### KENSINGTON GOLD MINE INSPECTION REPORT

**Inspection Date:** June 5, 2012  
**Weather:** Overcast, approximately 60°F, light wind, no precipitation  
**Time of Inspection:** 8:30 am to 2:30 pm  
**Operator Contact:** Kevin Eppers – Coeur Alaska  
**Agency Personnel:** David Wilfong – ADNR, Joe Manning – USFS, Kenwyn George  
ADEC  
**Inspection Objectives:** General Inspection

**Figure 3 Diversion Head Gate**

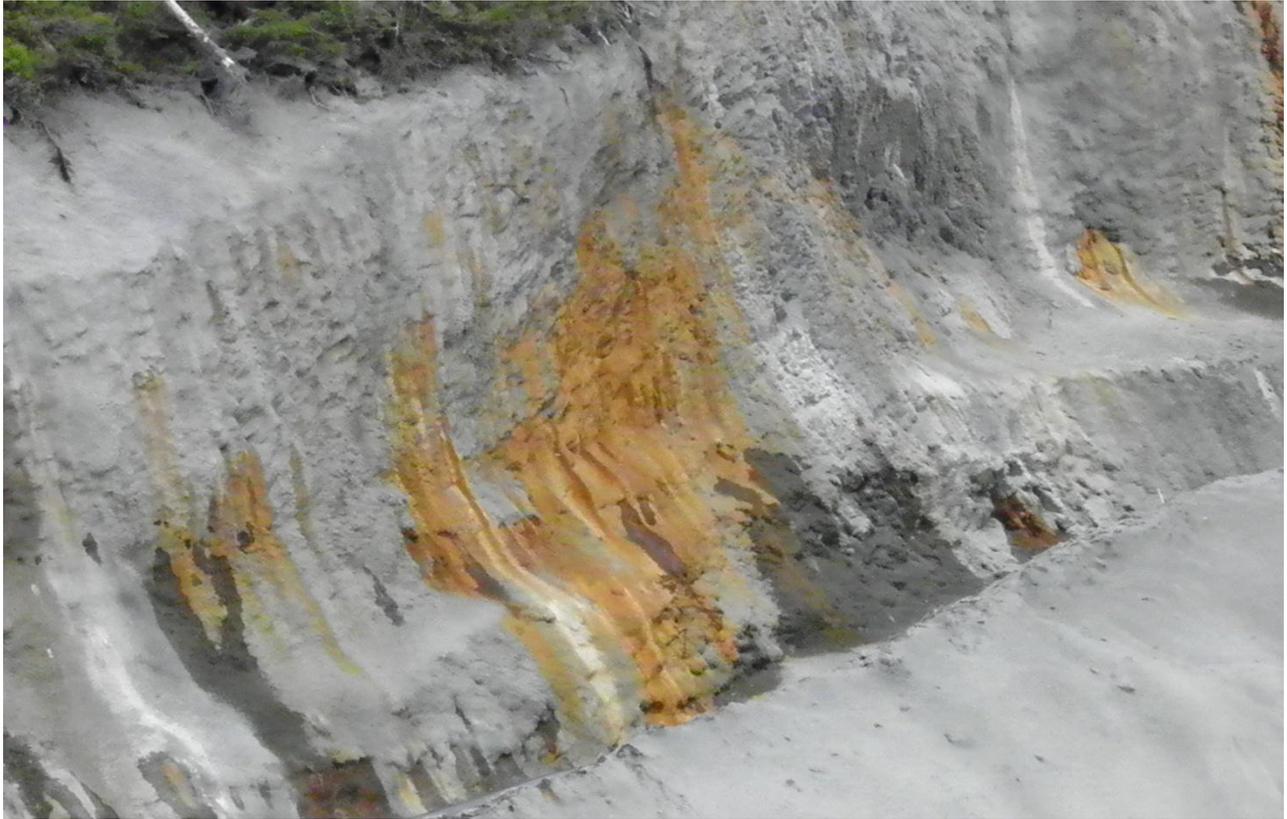
After a brief stop to examine a windfall area of trees, we continued on to the Tailings Treatment Facility (TTF). During the construction phase of the Stage 2 dam raise, the existing Emergency Spillway will be filled in and remain non-functional. Diversion tubes are in place to divert the major inflows into the TTF, but two of the diversion pipes at the northern end of the facility were found to have obstructions at the head gates (Figure 3). During a high flow precipitation event, the obstructions would lessen the ability of the tubes to divert clean water around the TTF, and could cause an unnecessary rise in the water level in the facility. Kenwyn George recommended that the obstructions be cleared before construction begins. Kevin Eppers agreed and said that the cleaning would be done.
